1103 Universal Transmitter

November 2016

Hardware Update

Figure 1: 1103 Universal Transmitter Housing

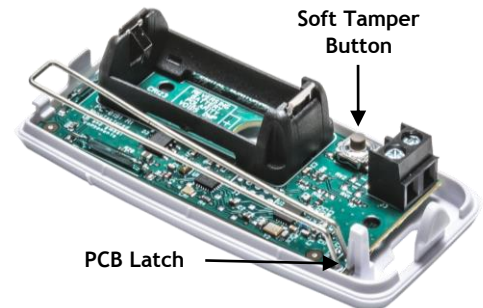
The 1103 case now features a streamlined plastic design that is easy to open and close. To open the case, press the button on the end of the 1103 and gently pull up on the transmitter cover. See Figure 1.

Figure 3: Wall Tamper

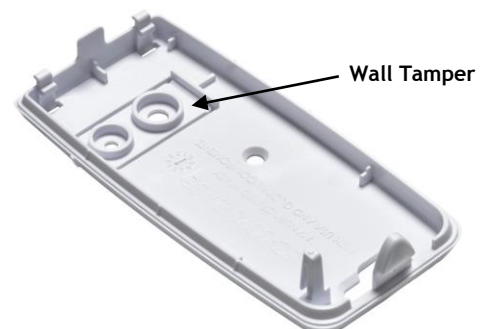
The 1103 no longer uses springs to trigger the wall or case tamper. The new design includes a breakaway wall tamper, as well as a built-in case tamper post which activates the soft tamper button on the PCB.
